February 28, 2017
BOARD OF COUNTY COMMISSIONERS
ORANGE COUNTY, FLORIDA
Y17-731-CC / ADDENDUM # 3
WITTENSTEIN COTTAGE ADA UPGRADES AND RENOVATIONS
Bid Opening Date: March 7, 2017

This addendum is hereby incorporated into the bid documents of the project referenced above. The following items are clarifications, corrections, additions, deletions and/or revisions to and shall take precedence over the original documents. Underlining indicates additions, deletions are indicated by ~~strike through~~.

Sheet Title:
DOOR, FRAME & HARDWARE SCHEDULES

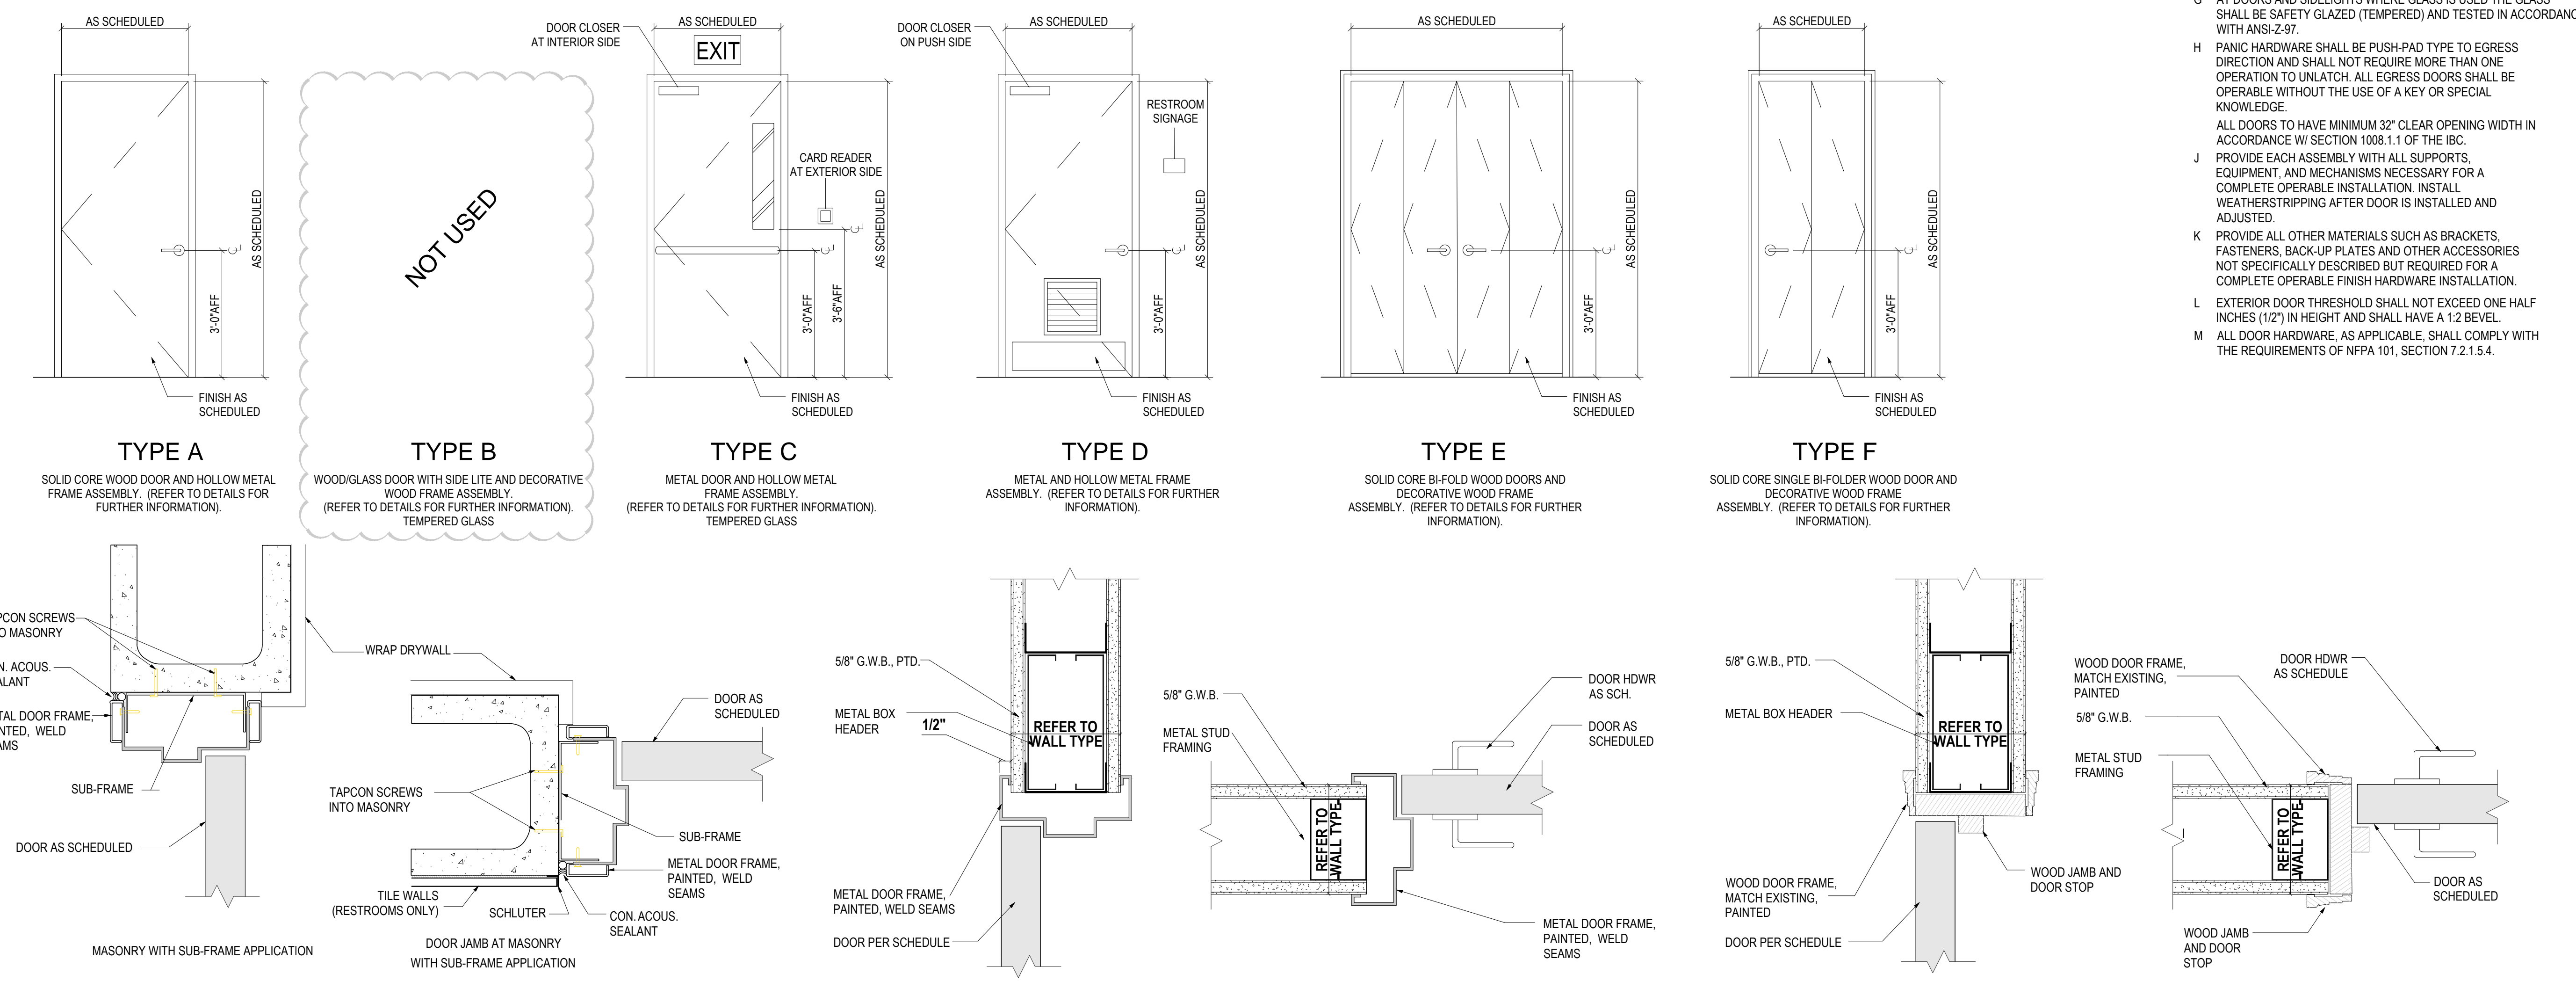
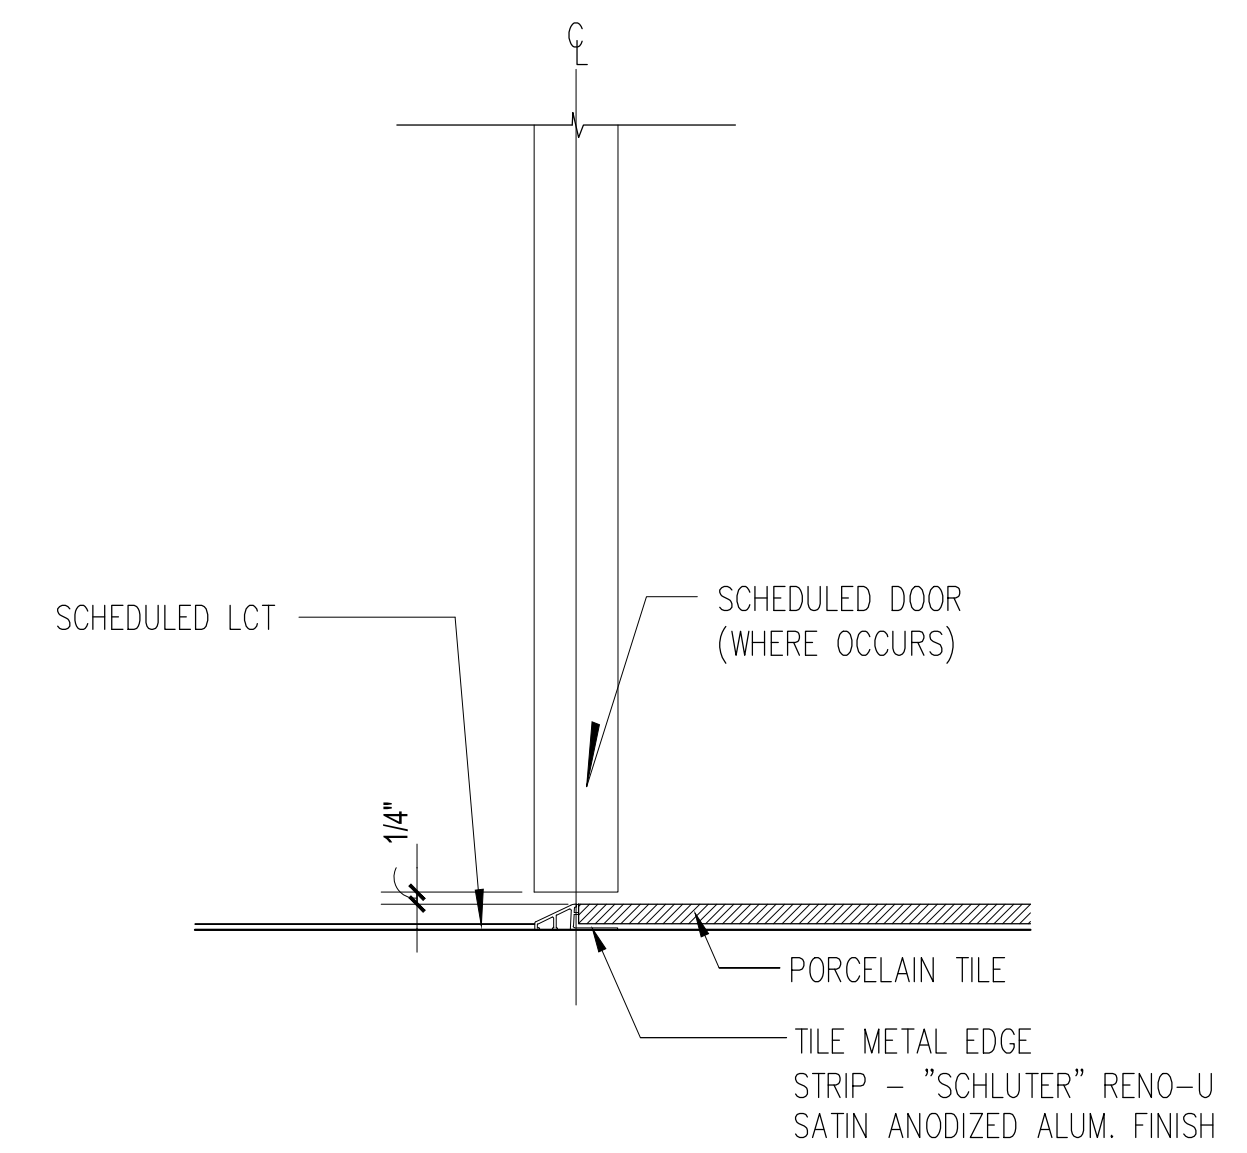
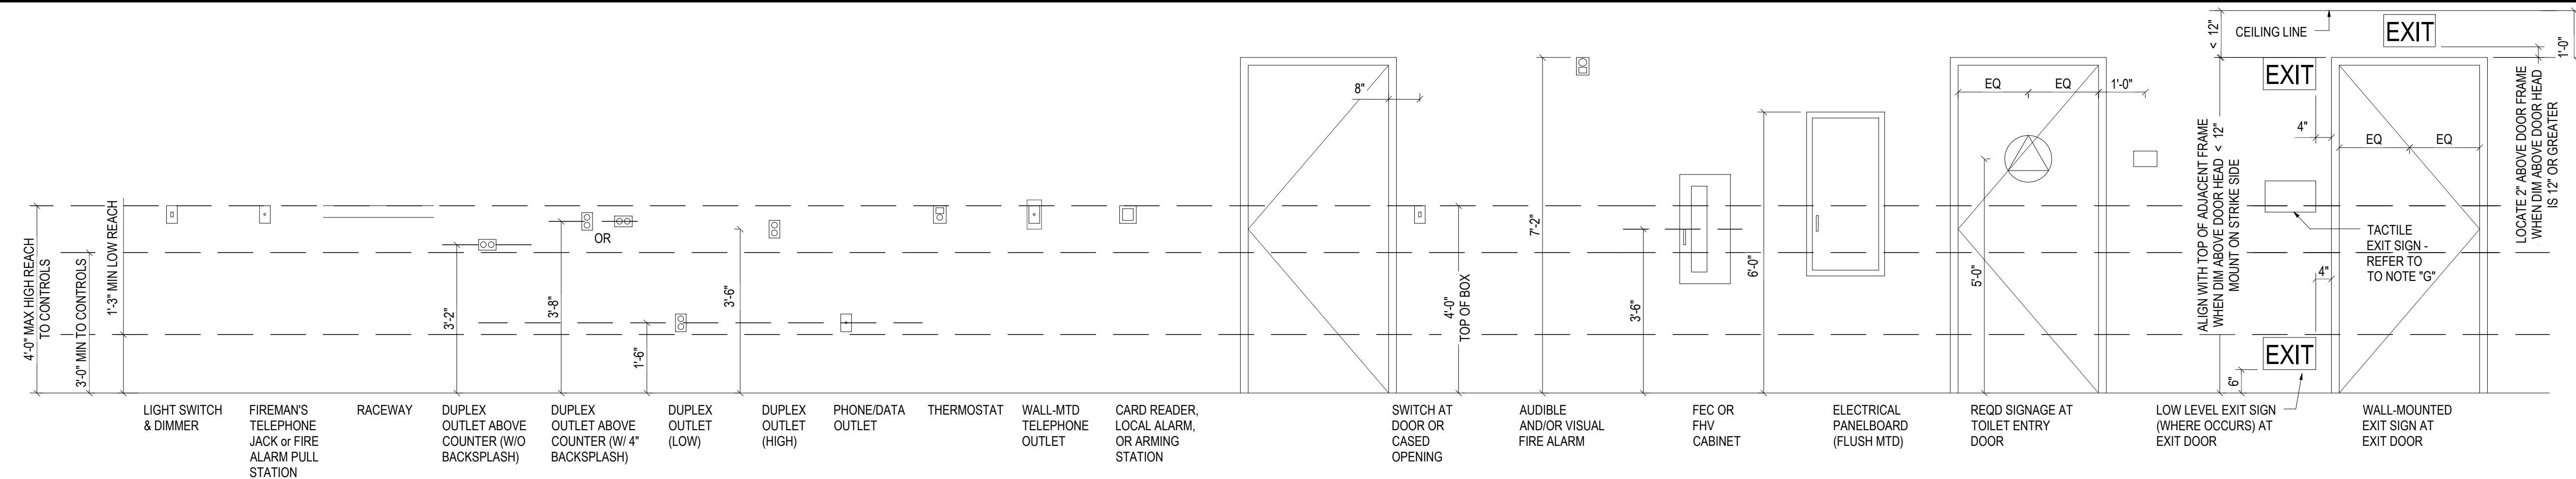
18.Question: Opening #101: Key note #10 on plan sheet A02.01 says to adjust closer to a door force of 5.5 lbs and furnish a lever handle to replace a knob, as needed. This door has a non-functioning closer already, and is currently a push/pull function. This door is not prepped to receive a lockset. Please advise correct hardware required at this opening.

19.Question: Note #10 on plan sheet A02.01 says to adjust closers and furnish lever handles to replace knobs, as needed. Please note that the doors currently at this facility are cylindrical locksets. The hardware sets are all specifying mortise locksets. Mortise locksets will not be compatible with the current doors to remain which will require new locksets. Please advise if cylindrical locksets are to be furnished everywhere, in lieu of mortise locksets, or only at existing doors to remain

20.Question: Openings #102, 104a, 107 and 109b: Please advise if these openings currently have knobs that will require new lever locksets.

21.Question: Opening #104b: Door has both a lockset and a deadbolt, which violates life safety code. Please advise if a new door will be required at this opening, or if the deadbolt hole will be filled in and a new cylindrical lockset furnished.

22.Question Opening #106d: Shown as a new door, frame and hardware per the demo plans, but is shown as existing per the door schedule. Please provide door, frame and hardware information on the door schedule.

23.Question: Opening #110a: Please advise if two separate door panels are required at this opening with the inactive leaf to be fixed in place by the millwork wood frame manufacturer, or if one door is to be furnished to go into a sidelite wood frame built and furnished by the millwork subcontractor.

24. Question: Openings #111b, 112a, 113b, 114a: We do not include rough buck hollow metal frames at these openings as shown in frame details 01 & 02/a00.30. Rough buck frames are not approved for Florida building code for windstorm. We include hollow metal frames in existing cmu partitions that are pierced and dimpled with existing masonry anchors for compliance with building code. Please confirm this application will be acceptable to the architect.

25. Question: Openings 111a & 113a: Please confirm that a privacy lockset with an occupancy indicator is the desired function at these rooms. One is a storage closet and the other a fire riser room.

26. Question: Opening 112a: Please confirm that a wood door is required at this boys restroom to match the other interior doors, in lieu of a metal door as shown on the door schedule.

27. Question: Hardware Sets #2 and #4: Both sets are specified as 'lockset passage' Schlage I9080. The Schlage I9080 lockset is a storeroom function lockset (continuously locked). Please confirm correct function and lockset.

Answer: Please refer to revised Hardware Set and Sheet Notes on attached Revised Sheet A00.30.

Answer: Please refer to revised Hardware Set and Sheet Notes on attached Revised Sheet A00.30.

Answer: Please refer to revised Hardware Set and Sheet Notes on attached Revised Sheet A00.30.

Answer: Please refer to revised Hardware Set and Sheet Notes on attached Revised Sheet A00.30 and Keynote 40 on Sheet A02.01.

Answer: Please refer to revised Hardware Set and Sheet Notes on attached Revised Sheet A00.30 and Keynote 8 on Sheet A02.01.

Answer: Please refer to revised Hardware Set and Sheet Notes on attached Revised Sheet A00.30 and Keynote 15 on Sheet A01.01.

Answer: The hollow metal frames are acceptable as stated on attached Sheet A00.30, door types A,C, and D.

Answer: Please refer to revised Hardware Set and Sheet Notes on attached Revised Sheet A00.30.

Answer: Both locker room doors for boys and girls require a metal door with louver due to heavy duty wear and tear. Door Type D on attached Sheet A00.30 shall be used.

Answer: Please refer to revised Hardware Set and Sheet Notes on attached Revised Sheet A00.30.
